**ANPR 50
(74FR40765)**

Michael C. Billone
Manager, Irradiation Performance Section

Subject: Comments on Proposed Rulemaking on 10 CFR 50.46 (ECCS Acceptance Criteria)
[RIN 3150-AH42]

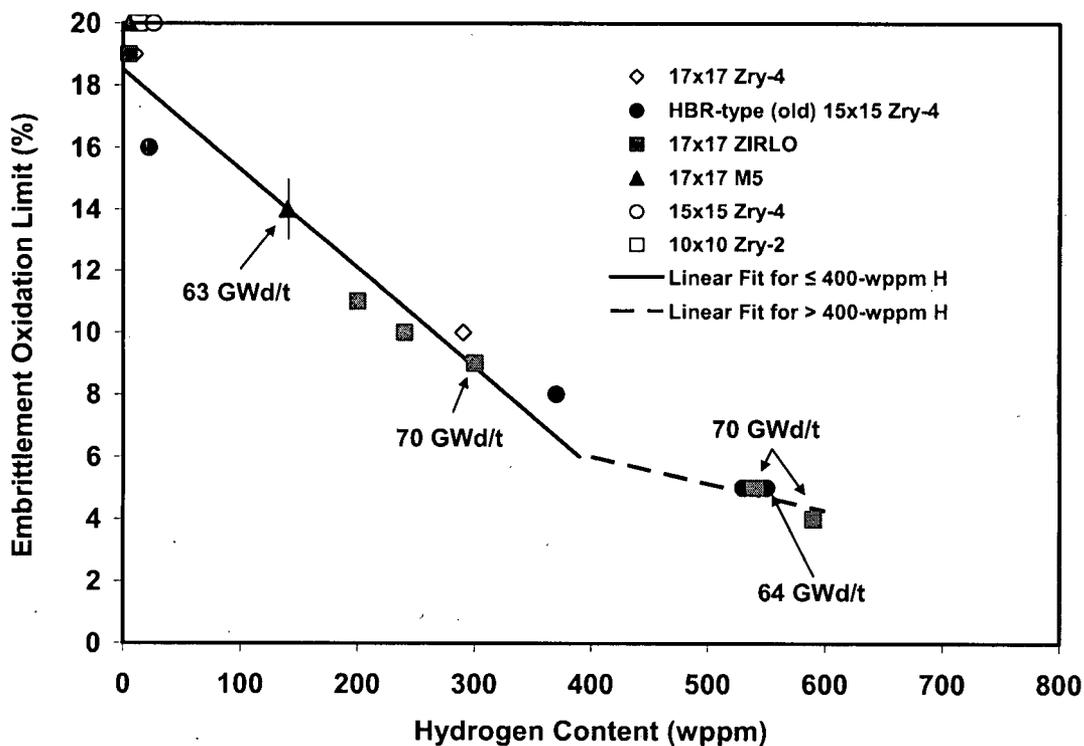
We understand that there is a need to create a more performance-based rule than the previous one. The use of a sliding scale for the oxidation limit already provides this improvement. For example, a cladding material such as M5, which absorbs very little hydrogen during its burnup lifetime, would have a much higher oxidation limit than, say, Zircaloy-4, which absorbs a lot of hydrogen. Based on trends deduced from Argonne data, the sliding scale of oxidation limit vs. hydrogen content should apply to new Zr-based cladding alloys as well as to the specific Zircaloy-4 (Zr-1.3%Sn), ZIRLO (Zr-1%Sn-1%Nb) and M5 (Zr-1%Nb) cladding materials tested. The Argonne data allow for direct comparison between Zry-4 and ZIRLO oxidation limits at

comparable hydrogen contents. The data for high-burnup M5 appear to be consistent with the Zry-4 and ZIRLO trend data. However, additional data for pre-hydrated M5 and pre-hydrated Zircaloy-4 with 100-200 wppm hydrogen would increase the confidence level of using the sliding scale for new cladding alloys.

Paragraph c under Testing Considerations describes the possibility of using pre-hydrided fresh cladding as a surrogate for irradiated cladding in tests for post-quench ductility. In Paragraph c and in the appendices, it is implied or stated that the NRC has not yet accepted the use of this surrogate material. Although additional demonstration of the surrogate's adequacy is desirable, recent ANL data described herein (see figure on page 4) further support the validity of this surrogate.
